Technical Service Bulletin

26-BE-001H

**INOPERATIVE HORN ASSEMBLY REPLACEMENT
(WARRANTY EXTENSION Z09)**

Description: Certain Santa Fe Hybrid (TM HEV) and Santa Fe Plug-In Hybrid (TM PHEV) vehicles may have an inoperable horn that may be caused by foreign substances causing internal parts to oxidize.

Before

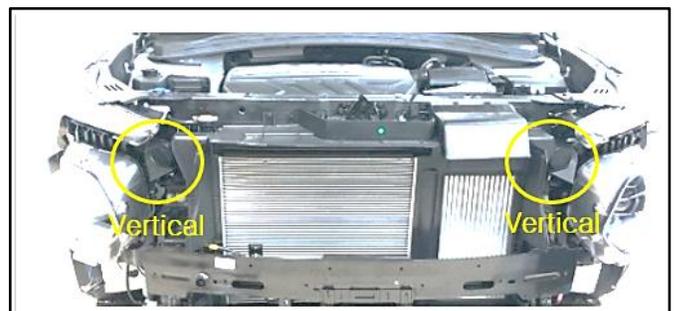
If a horn needs to be replaced, follow the instructions within this TSB to install the latest design.

5. Install the new horns in a vertical orientation.
6. Reinstall parts in the reverse order of the removal process.
7. This service procedure is now complete.

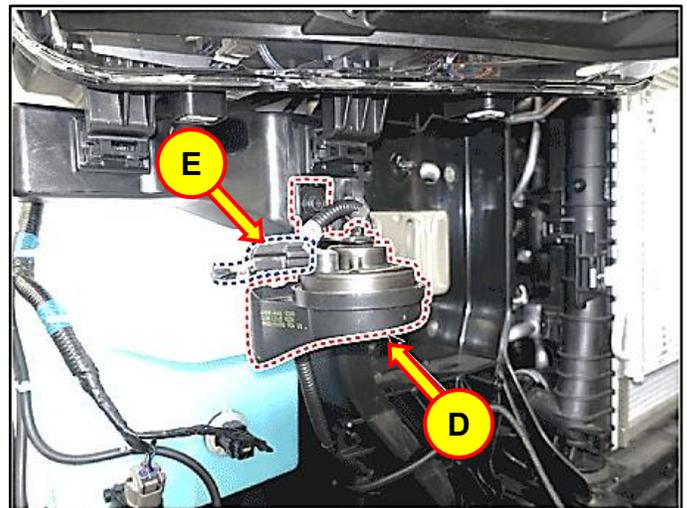
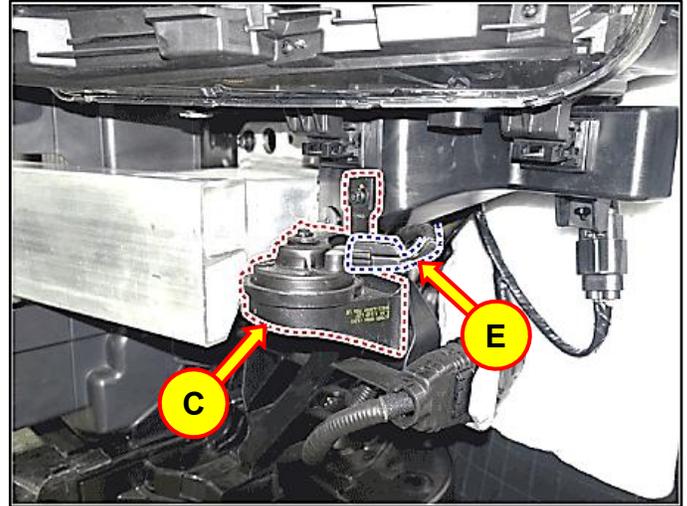
4. Refer to the shop manual to remove both horns (C, D) by disconnecting the horn connector (E) and removing the mounting bolt:
- **Body Electrical System > Horn > Repair procedure**
